Cabinet Member for City Services

1. **Apologies**
2. **Declarations of Interests**
3. **Minutes** (Pages 5 - 12)
 - (a) To agree the minutes of the meeting held on 8th November 2024
 - (b) Matters Arising
4. **Binley Cycleway - Section 7 (Clifford Bridge Road)** (Pages 13 - 92)

Design review feedback: ATE00676 Binley Road Coventry to University Hospital route

Network Map

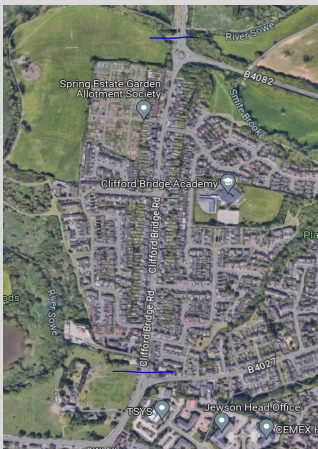
Factor	Mode	#	Metric	Critical Issue	Red	Amber	Green	Existing	Proposed
				C	0	1	2		
SAFE									
Collision Risk	Walking / Wheeling / Cycling	1	Conflict with motor traffic at side roads / priority junctions	>2500vpd cut across main cycling or walking streams	Side roads / priority junctions are untreated.	Side roads / priority junctions have entry treatments.	Side roads / priority junctions are either closed to motor traffic, or have continuous footway or zebra crossings.	C	1
	Walking / Wheeling / Cycling	2	Conflict with motor traffic at signal controlled junctions and roundabouts	>2500vpd cut across main cycling and/or walking streams	Pedestrian and/or cyclist movements are in conflict with motor traffic movements at signal controlled junctions and roundabouts.	The principal pedestrian and cyclist movements are separated from motor traffic movements at signal controlled junctions and roundabouts.	All pedestrian and cyclist movements are separated from all motor traffic movements at signal controlled junctions and roundabouts.	C	C Cyclists bypass the junction, but pedestrians cross uncontrolled at the B4082 roundabout

Link Check Assessment Results

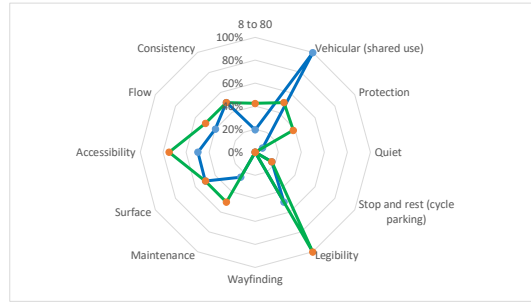
Principle	Existing Layout	Proposed Layout - Detailed Design
8 to 80	19%	42%
Vehicular (shared use)	100%	50%
Protection	7%	38%
Quiet	0%	0%
Stop and rest (cycle parking)	17%	17%
Legibility	50%	100%
Wayfinding	0%	0%
Maintenance	25%	50%
Surface	50%	50%
Accessibility	50%	75%
Flow	40%	50%
Consistency	50%	50%
Overall ATE Score	19%	42%
Number of critical issues	5	1
